DWR EXHIBIT I
Application, File No. 45,574

**APPLICATION FOR PERMIT TO
APPROPRIATE WATER FOR BENEFICIAL USE**
Filing Fee Must Accompany the Application
(Please refer to Fee Schedule attached to this application form.)

ASR Project DW-7

Re: Application
File No. 45,574

Figure 5.

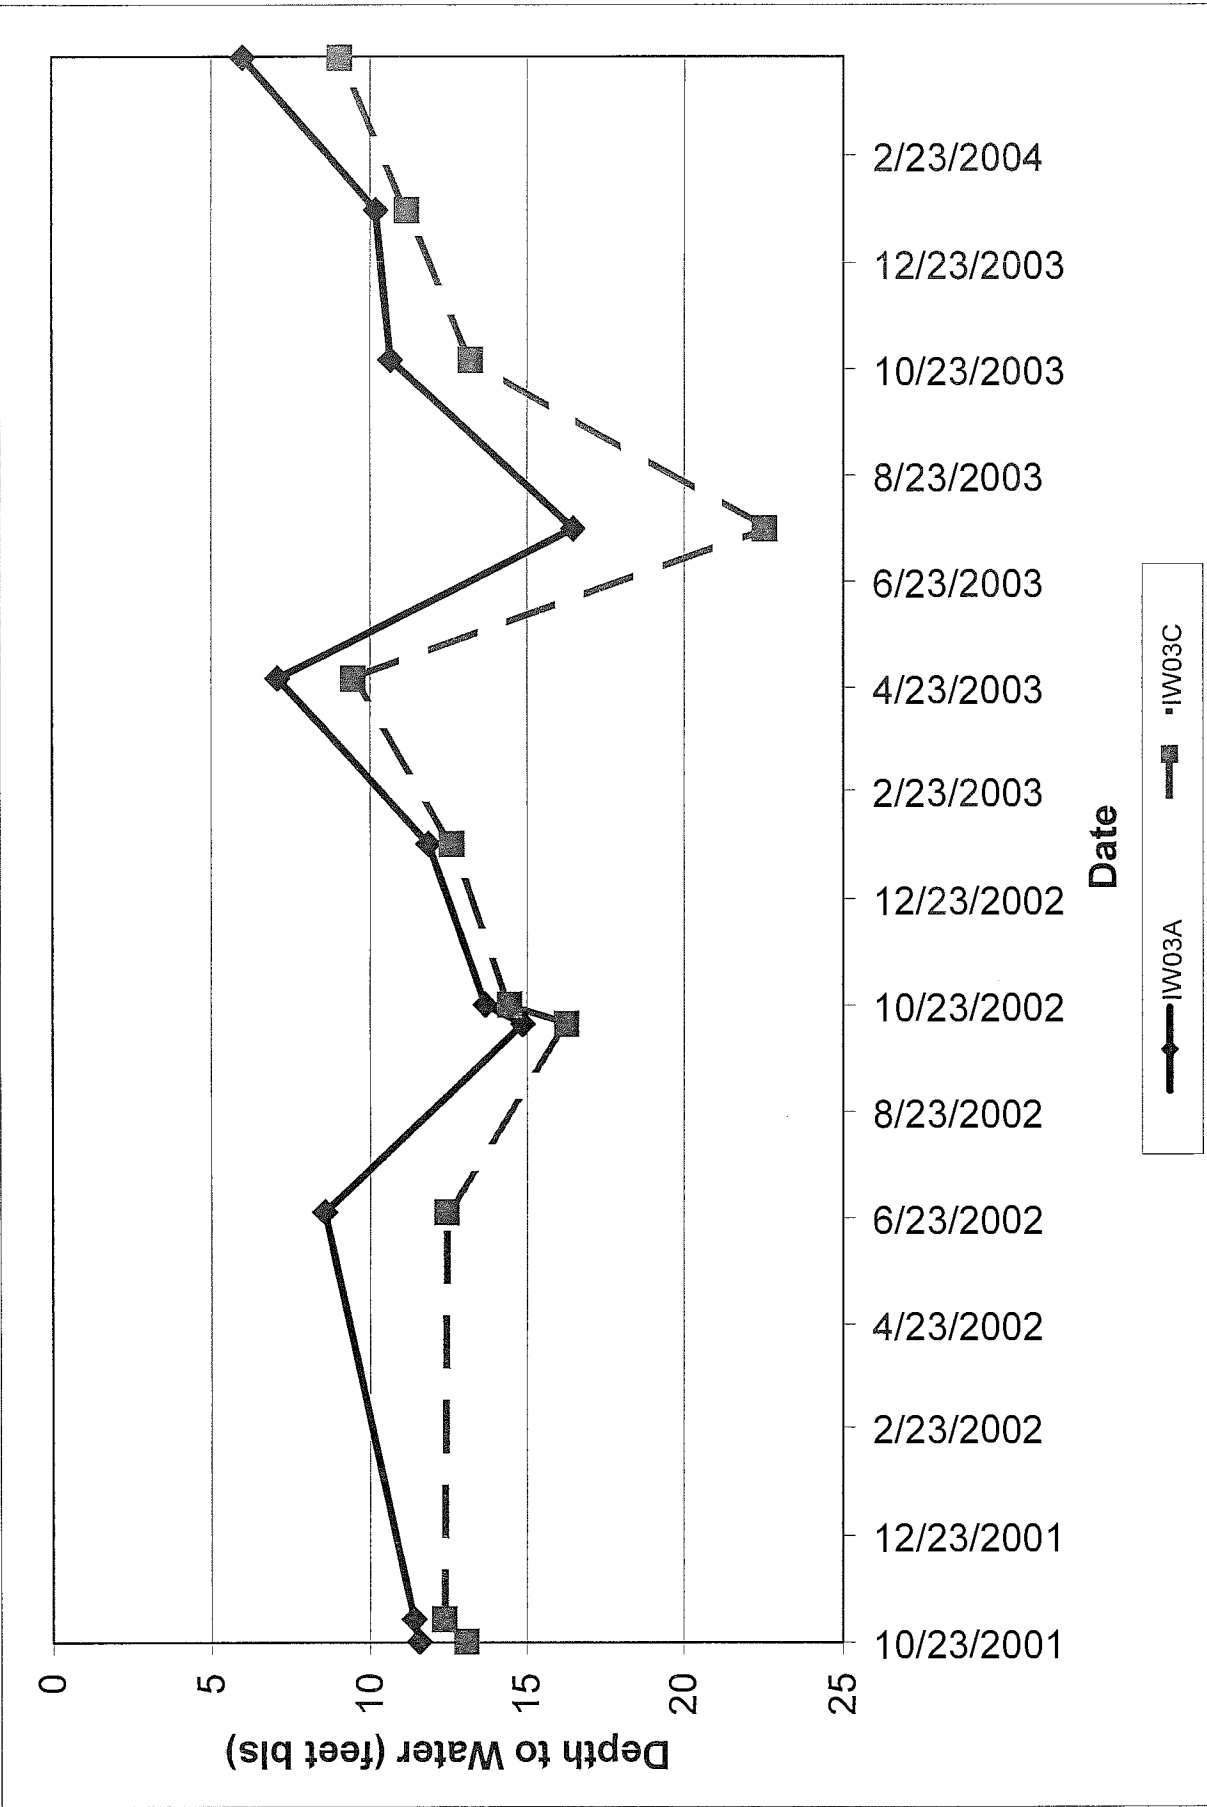
Water level data has been recorded by the District at groundwater monitoring site IW03 located approximately 0.6 mile south-southwest of the proposed well site (figure 3). Water levels recorded at the site during the period of record from October 2001 to April 2004 (figure 5), ranged from 5.99 to 16.49 feet bls in IW03A (total depth 34 feet), and from 9.03 to 22.53 feet bls in IW03C (total depth 138 feet). The IW03C lithologic log reported that depth to bedrock was 166 feet bls.

IW03 water level data (figure 5) indicated that a head difference ranging from approximately 1 to 6 feet existed between the upper zone (A well) and the lower zone (C well). The water levels in both zones exhibited similar responses to water table fluctuations, indicating a hydraulic connection. The fluctuation responses indicated leakage occurrence from the upper zone to the lower zone. Pumping effects exhibited in the lower zone also affected water levels in the upper zone. The correlation between the data sets indicated that the clay unit separating the two zones is not continuous throughout the area.
